# Access Compliance Report

## Public Rights-of-Way

Intersection ID: 45280	Main Street: LAKEHILL_RD	Cross Street: VALLEY_RIDGE_RD	Location: SE
ADA ID: D2C33EEE8770	Ramp Type: PerpDiag	Initial Pass/Fail: Fail	Overall Compliance: No
			Severity Score: 46.25

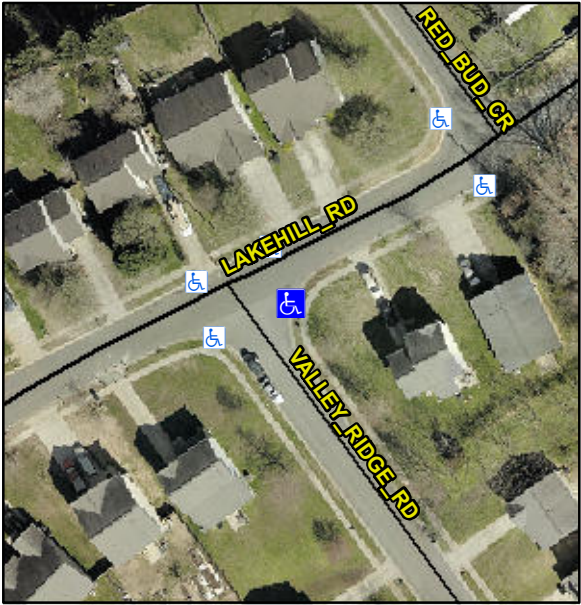
Codes/Mitigation Info/Possible Solution			Field Measurements/Component Compliance		
	Possible Solutions:		<b>Compliance</b>	<b>Description</b>	<b>Data</b>
	<b>Remove &amp; Replace Curb Ramp With Two New Directional Ramps or Equivalent.</b>		<b>No</b>	Ramp Length (in)	<b>48.0</b>
			<b>No</b>	Ramp Width (in)	<b>41.0</b>
			<b>N/A</b>	Flare Type LT	<b>N/A</b>
			<b>N/A</b>	Flare Slope LT (%)	<b>N/A</b>
			<b>N/A</b>	Flare Traversable LT?	<b>N/A</b>
			<b>N/A</b>	Landing Length (in)	<b>N/A</b>
			<b>N/A</b>	Landing Width (in)	<b>N/A</b>
			<b>N/A</b>	Landing Slope (%)	<b>N/A</b>
			<b>N/A</b>	Landing X Slope (%)	<b>N/A</b>
<p>Surveyor Notes:</p> <p><b>N/A</b></p> <p>PROW/ADA:</p> <p><b>Not Found, R304.5.1, R304.2.2, R304.5.3</b></p>			<b>N/A</b>	Flare Type RT	<b>N/A</b>
			<b>N/A</b>	Flare Slope RT (%)	<b>N/A</b>
			<b>N/A</b>	Flare Traversable RT?	<b>N/A</b>
			<b>N/A</b>	DWS Provided?	<b>N/A</b>
			<b>N/A</b>	DWS Contrast?	<b>N/A</b>

<b>N/A</b>	DWS Length (in)	<b>N/A</b>
			<b>N/A</b>	DWS Full Width?	<b>N/A</b>
			<b>N/A</b>	DWS Offset (in)	<b>N/A</b>
			<b>N/A</b>	Gutter Ponding?	<b>N/A</b>
			<b>N/A</b>	Gutter Lip Ht (in)	<b>N/A</b>
			<b>No</b>	Painted X Walk1?	<b>No</b>
				X Walk 1 Direction	<b>To N</b>
			<b>N/A</b>	X Walk 1 Width (in)	<b>N/A</b>
			<b>4.6</b>	X Walk 1 Slope (%)	<b>4.2</b>
			<b>4.1</b>	X Walk 1 X Slope (%)	<b>8.8</b>
			<b>N/A</b>	Ramp inside XWalk1?	<b>N/A</b>
			<b>7.5</b>	Road Slope (%)	<b>N/A</b>
			<b>3.6</b>	Road X Slope (%)	<b>N/A</b>
			<b>N/A</b>	Any Obstructions?	<b>N/A</b>
				Obstruction Type	
Total Cost: \$ 3200.00			<b>N/A</b>	Storm Grate/Utility Hazard?	<b>N/A</b>
			<b>N/A</b>	Storm Grate/Utility Type	
			<b>N/A</b>	Surface Condition? (G/P)	<b>Good</b>
